INDESIT company

Model type:
T5FNFFR

Commercial code:
F037101

## 0999369: FAN MOTOR MODIFICATION FOR DECREASING NOISE LEVEL

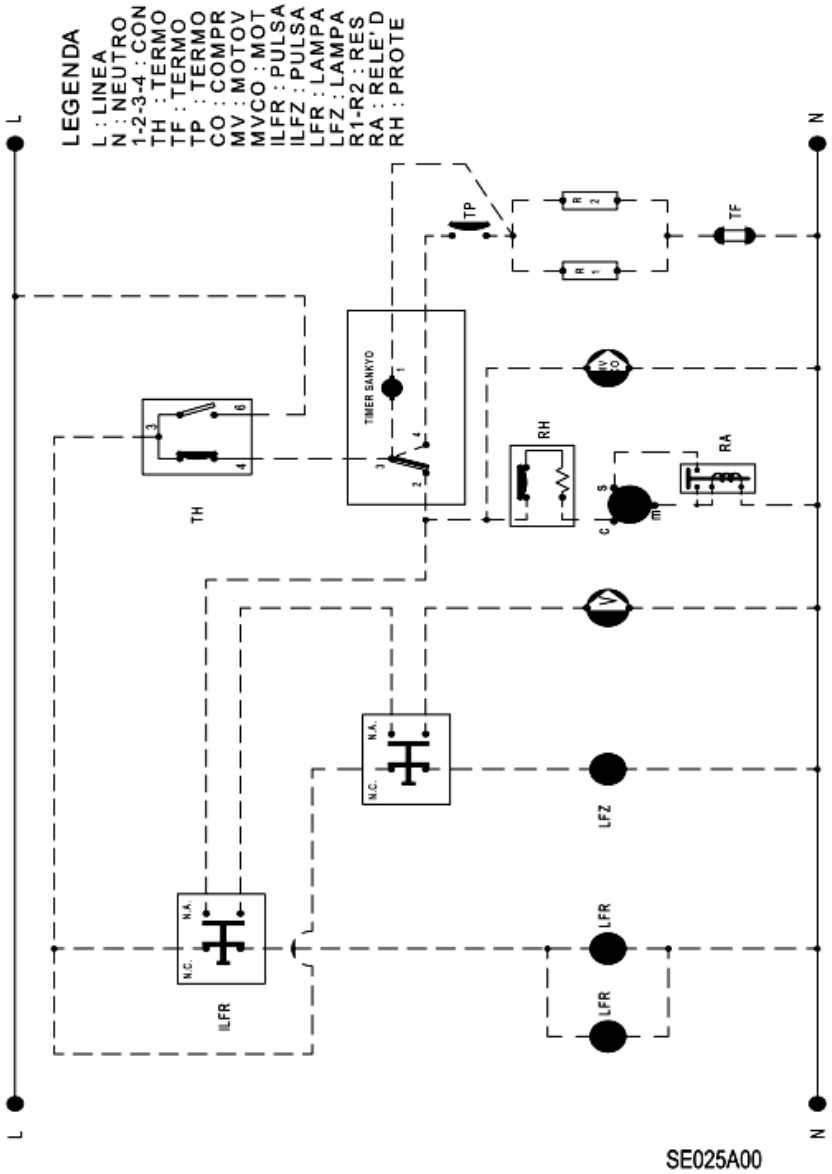
From serial number 50625.0001 on electronic no-frost models and from serial number 50723.0001 on mechanic no-frost models freezer fan motor has been modified for decreasing noise level.

Modified parts:
139648 - fan motor
119866 - fin evap cover assembly
140463 - freezer rear cover assembly
140462 - fast feezer cover
140662 - damper styrofoam (eps)
140661 - multiflow upper cover
140663 - multiflow styrofoam (eps)

Premodified parts:
174380 - fan motor
173745 - fin evap cover assembly
174886 - freezer rear cover assembly
174992 - fast freezer cover
174943 - damper styrofoam (eps)
090287 - multiflow upper cover
174944 - multiflow styrofoam (eps)

Since RPM of the new motor is lower than the previous one, new fan motor is not interchangeable with the old one, and it cannot be used on the premodified appliances.
